# UPDATE Technical Bulletin

17 12 01 March 09, 2012 2028830

## UPDATE – 17D2 Positive Crankcase Ventilation Valve

Figure 1: Pressure Control Valve (1). Gasket (2), Pipe gasket (3),

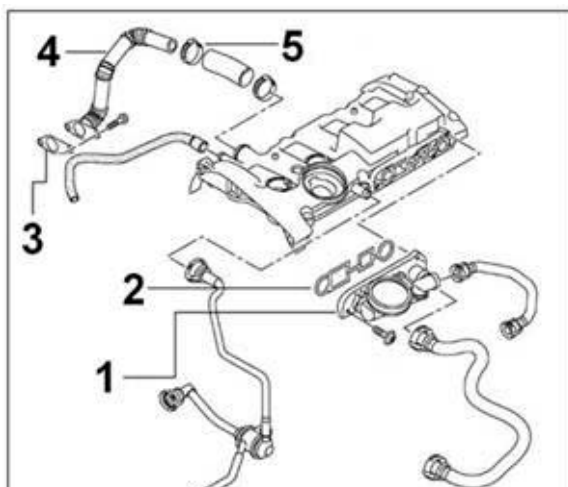
Remove Pressure Control Valve (Figure 1, 1) and check part number.

If the part number of the pressure control valve is **06F 129 101 P** no further steps are required.

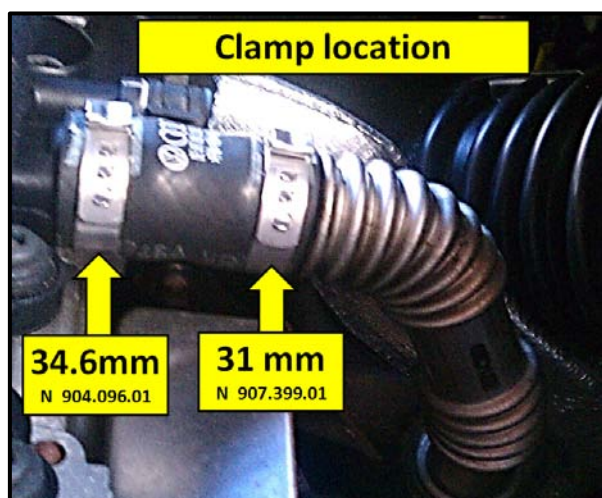
If the part number of the Pressure Control Valve is **any other suffix prior to “P”**, replace Pressure Control Valve

Inspect intake turbo pipe. If the intake turbo pipe is not part number 06F 103 215B replace.

Tip: Picture <left> shows correct location of clamps.

Tip: To install 31mm clamp, first insert clamp onto turbo pipe, then insert turbo pipe into rubber hose, then slide clamp over rubber hose.

- Install improved pressure regulating valve and turbo pipe.
